Clause 104 Maintenance Requests #3

Overview

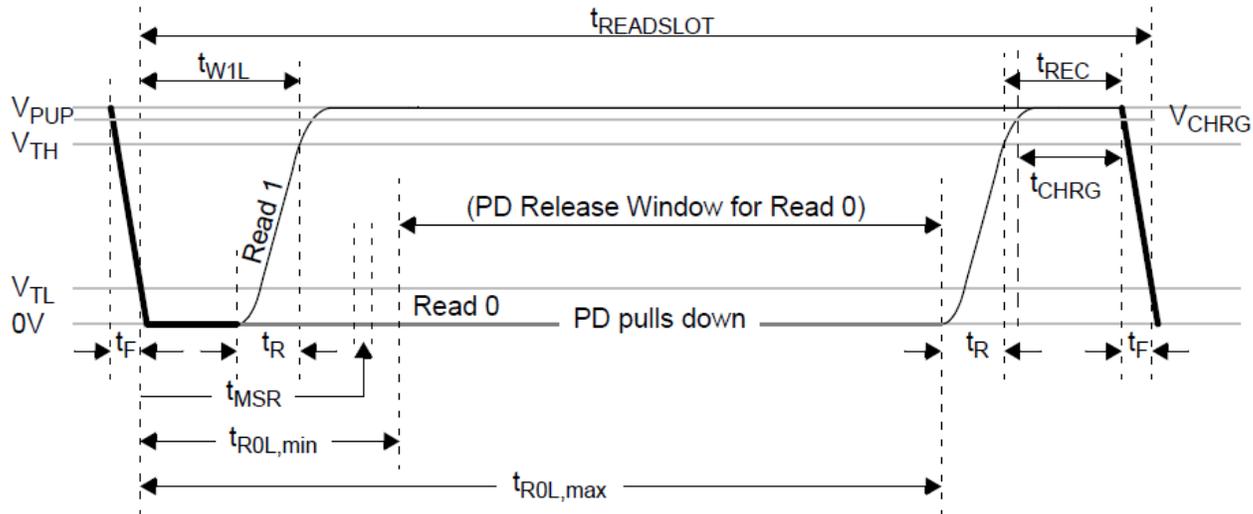
- ▶ C_{IN_CLASS} is limited to ensure that excessive rise and fall times do not interfere with SCCP
 - Other timing parameters are affected by C_{IN_CLASS}
 - t_R and t_F were generous and can already accommodate C_{IN_CLASS} of up to 0.8uF
- ▶ C_{IN_CLASS}, max is 0.4uF for Type E
- ▶ This value is unnecessarily restrictive and potentially infeasible
 - A reservoir cap is required to maintain PD operation during Reset commands

Modify Table 104-7, Item 6b

6b	Input capacitance during DO_CLASSIFICATION state	C _{IN_Class}	μF	—	0.2	A, A₁ <u>B, C,</u> <u>D</u>	All classes <u>Applies during t_R and t_F only.</u>
				=	0.4 <u>0.8</u>	<u>E</u>

SCCP Reset Command Timing

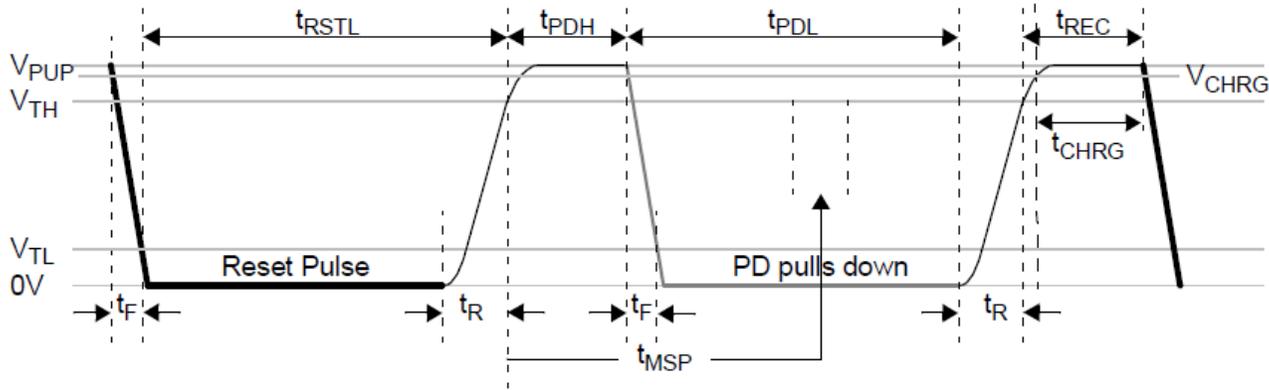
- ▶ C_{IN_CLASS} change lengthens real-world Reset component timings
- ▶ T_{PDL} was by far the tightest PD timing accuracy requirement
 - Make rationale and economically feasible by increasing to $\sim\pm 20\%$
- ▶ Incorporate t_{REC} change for Type E as proposed previously
- ▶ **Propose:** Changes as shown, editorial license to split rows

Parameter	Min	Max
t_F	0.025	0.25
t_{RSTL}	8	10.5
t_{PDH}	0.7	1.3
<u>(Type E) t_{MSP}</u>	1.8	2.2 <u>2.4</u>
$t_{PDL, E}$	2.8	5.2
$t_{PDL, E}$ w/ CRM	21	34 <u>39</u>
t_R	0.025	0.5
<u>(Type E) t_{REC}</u>	0.27 <u>0.5</u>	0.33

SCCP t_{READSLOT} Timing

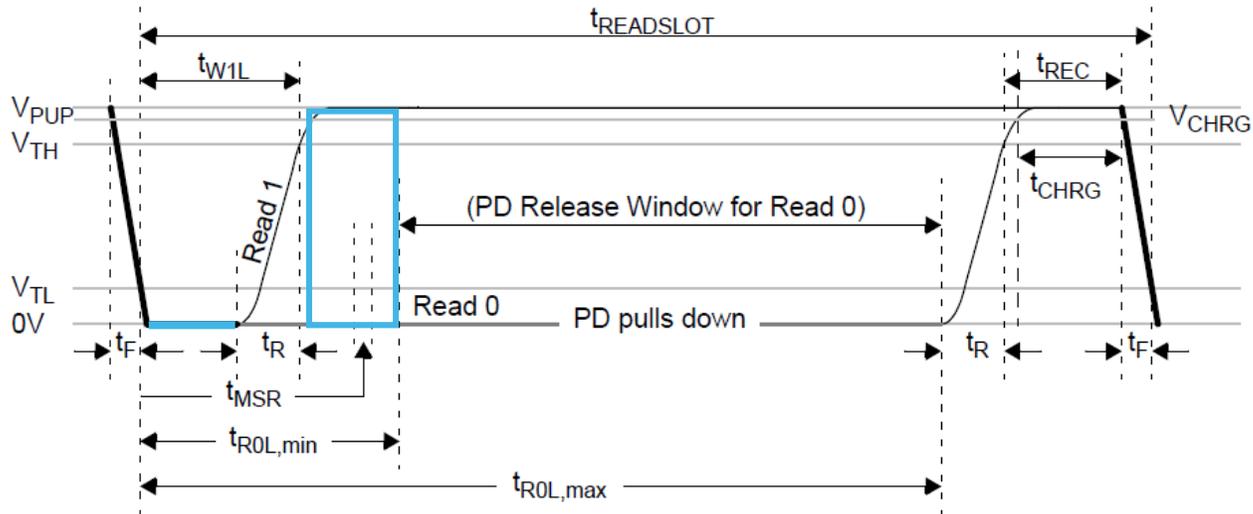
- ▶ Late changes to Read Slot component timing affected t_{READSLOT} but were not accounted correctly
 - Original $t_{\text{READSLOT,max}}$ did not correlate to sum of components
 - ▶ Original calcs did not account for PSE and PD discrepancies for t_{R} and t_{F} in end-to-end systems
 - ▶ Incorporate t_{REC} change for Type E as proposed previously
 - ▶ **Propose:** Changes as shown, editorial license to split rows
- Need to Address: Consensus
Solution Details: Consensus

Parameter	Min	Max
t_{F}	0.025	0.25
t_{MSR}	0.9	1.4 <u>1.3</u>
t_{R0L}	1.75	3.25
t_{R}	0.025	0.5
<u>(Type E) t_{REC}</u>	0.27 <u>0.5</u>	0.33
t_{READSLOT}		3.83 <u>5</u>

SCCP $t_{\text{WRITESLOT}}$ Timing

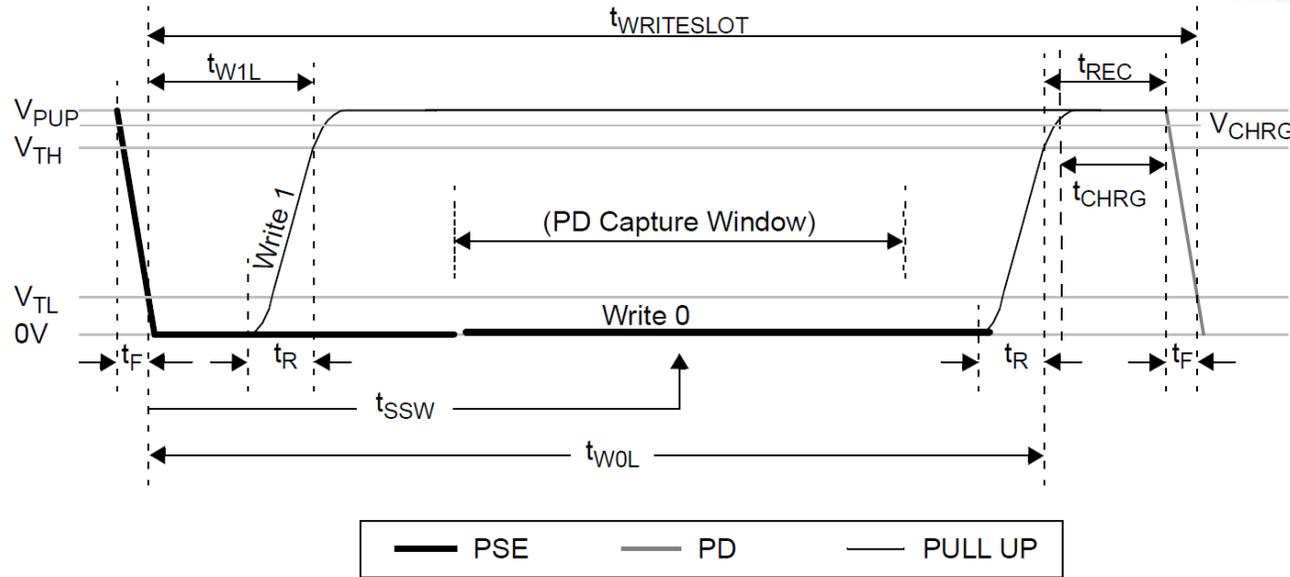
- ▶ Original calcs did not account for PSE and PD discrepancies for t_R and t_F in end-to-end systems
- ▶ C_{IN_CLASS} change lengthens real-world Write Slot component timings
- ▶ Incorporate t_{REC} change for Type E as proposed previously
- ▶ **Propose:** Changes as shown, editorial license to split rows

Parameter	Min	Max
t_F	0.025	0.25
t_{W1L}	0.09	0.61 <u>0.64</u>
<u>(Type E)</u> t_{W0L}	1.8	2.2 <u>2.6</u>
t_R	0.025	0.5
<u>(Type E)</u> t_{REC}	0.27 <u>0.5</u>	0.33
$t_{WRITESLOT}$		2.78 <u>3.85</u>

SCCP t_F Timing

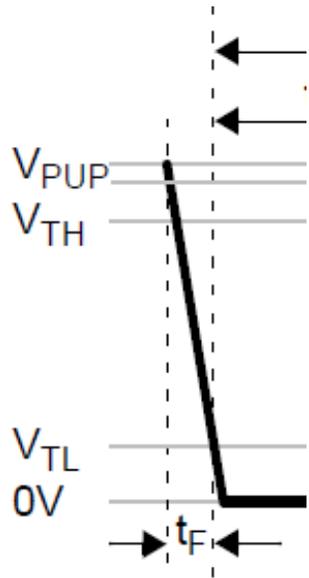
- ▶ $t_{F,min}$ is over-specified and serves as a design recommendation while serving no interoperability value
 - Strong negative effect on economic feasibility
- ▶ **Propose:** Change as shown for Type E

Parameter	Min	Max
t_F	0.025 <u>0</u>	0.25

Figure 104-10—Reset command timing diagram

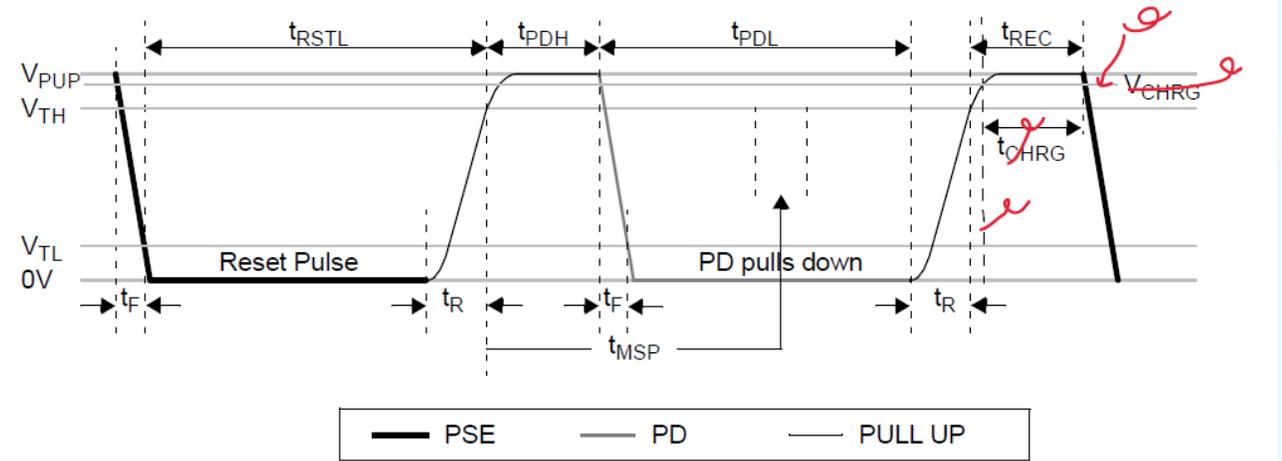
V_CHRG and t_CHRG requirements are limiting without bringing value to the standard.

Modify Figure 104-10 as shown.

Remove V_CHRG and associated voltage line.

Remove t_CHRG arrow and text.

Remove timing reference dashed line at right end of t_CHRG arrow.

Figure 104-11—Write 0/1 slot timing diagram

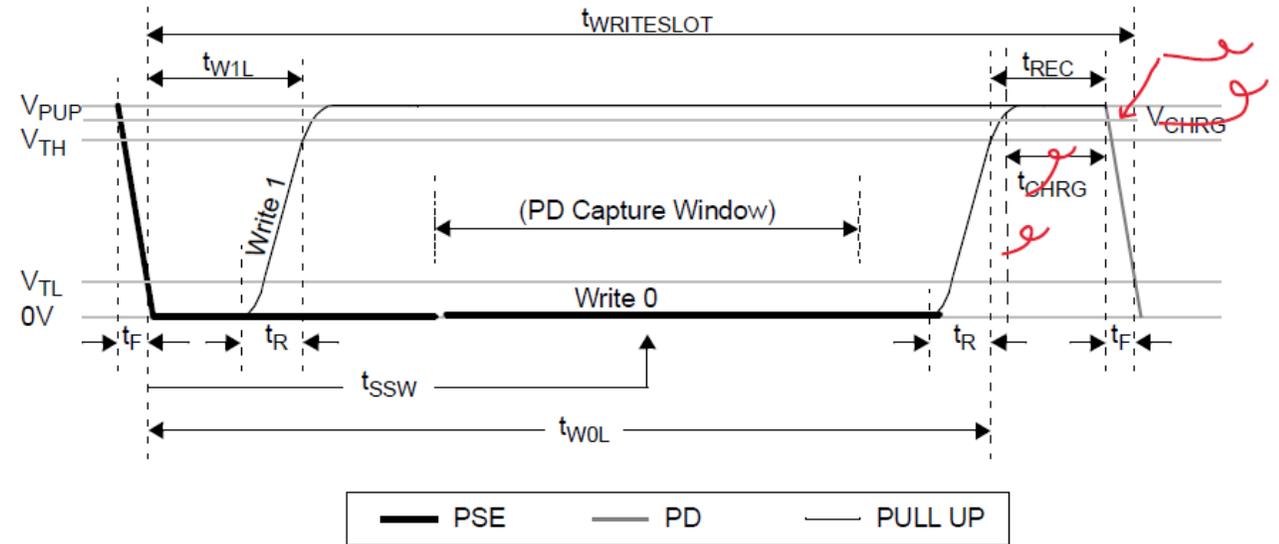
V_CHRG and t_CHRG requirements are limiting without bringing value to the standard.

Modify Figure 104-11 as shown.

Remove V_CHRG and associated voltage line.

Remove t_CHRG arrow and text.

Remove timing reference dashed line at right end of t_CHRG arrow.

Figure 104-12—Read 0/1 slot timing diagram

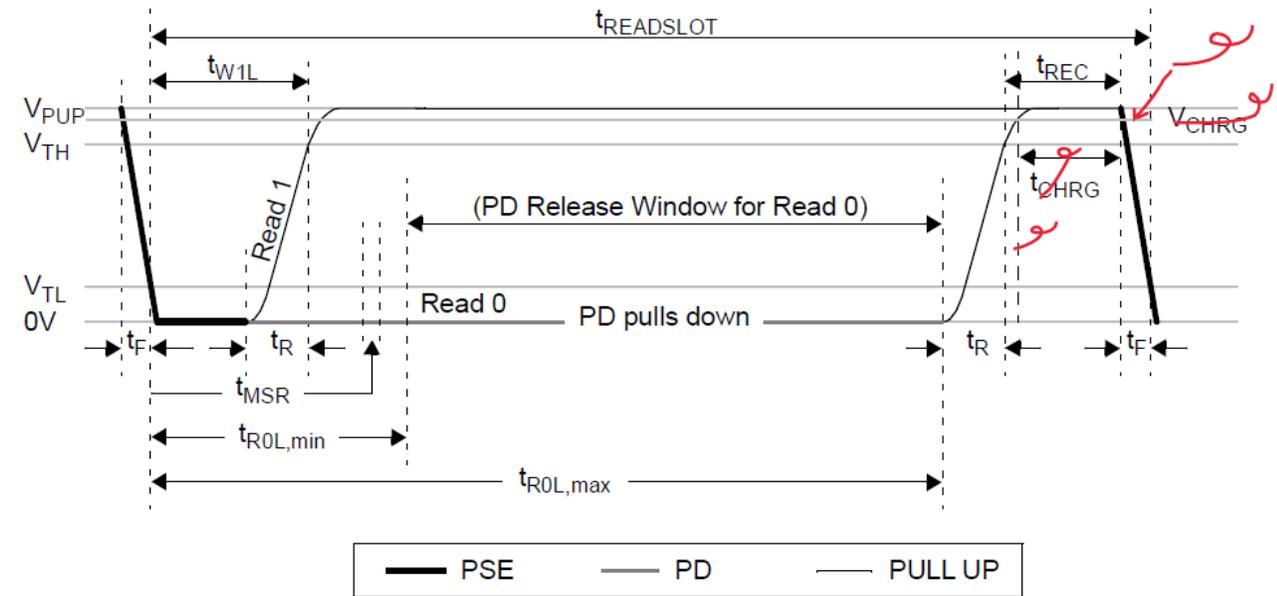
V_CHRG and t_CHRG requirements are limiting without bringing value to the standard.

Modify Figure 104-12 as shown.

Remove V_CHRG and associated voltage line.

Remove t_CHRG arrow and text.

Remove timing reference dashed line at right end of t_CHRG arrow.
